### Summary of post-submission elevation and massing amendments to Building F

Environment Agency & Friends of the River Crane comments

## 8.6 Planning objection comments

Project number	A2871
Project title	Greggs Bakery, Twickenham
Document title	Design and Access Statement
Client	London Square Developments Ltd
Document status	Planning Submission
Date of issue	14 December 2022
Prepared by	Chloe Simons, Architectural Assistant
Checked by	Ed Sharland, Associate Director

Planning submitted elevation

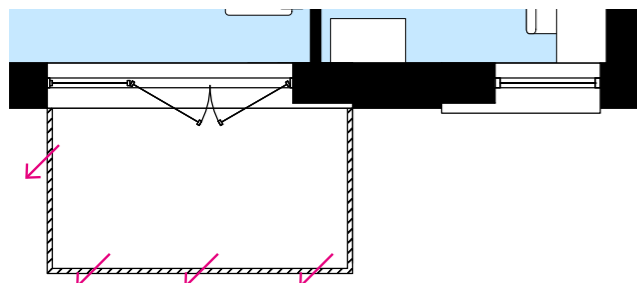
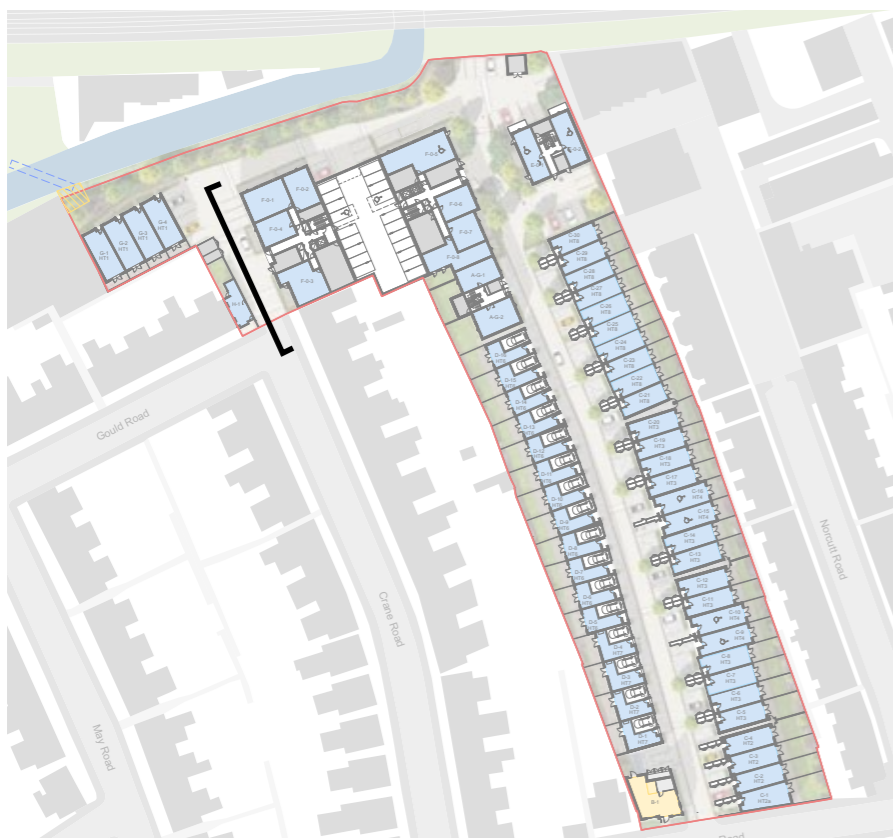
1. Top floor and roofscape – reduced angle and change of material;
2. Balcony design amended;
3. Massing reduced by lowering the top floor parapet and the communal roof terrace omitted.

Amended elevation

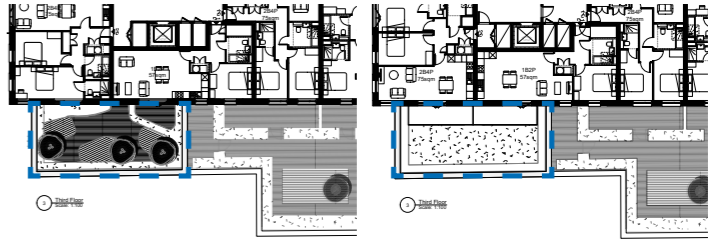
**Overlooking & privacy**  
 A number of comments submitted related to overlooking of gardens or rooms from the proposals.

To mitigate overlooking south east towards Alcott House rooms and gardens from Building E oriel windows were introduced. The adjacent plans demonstrate the overlooking arc of oriel windows angled 30 degrees away from Alcott House. The overlooking arc does not reach Alcott House from any window.

To mitigate overlooking south towards Crane Road houses rooms and gardens the roof terrace was re-designed as an intensive green roof with the minimum external provision for the apartments fronting the roof terrace and no access for other residents.

Option 1 - Bridge location over the river and railway

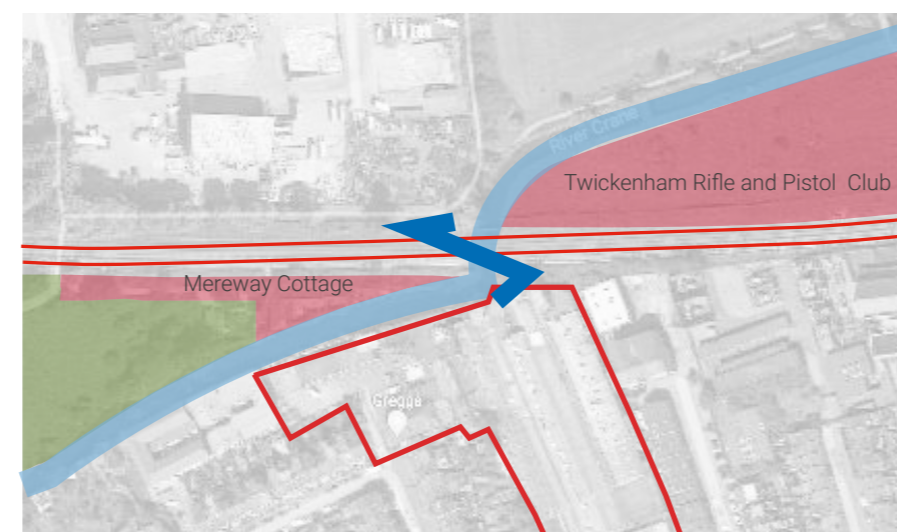
In response to comments made at the public consultation we have looked at the possibility of facilitating a new pedestrian crossing over the River Crane as part of the design process.

Option 1 would require a bridge to go over both the railway line and river. This would require the bridge to go up a significant height and traverse a long distance. It would also need to be approved by Network Rail.

Option 2 requires a diagonal span to the Mereway Nature Park. This is dependent on ground conditions to the west and is likely to have a negative effect on the biodiversity of the nature park.

It is considered option 2 is the only feasible option for a future bridge.
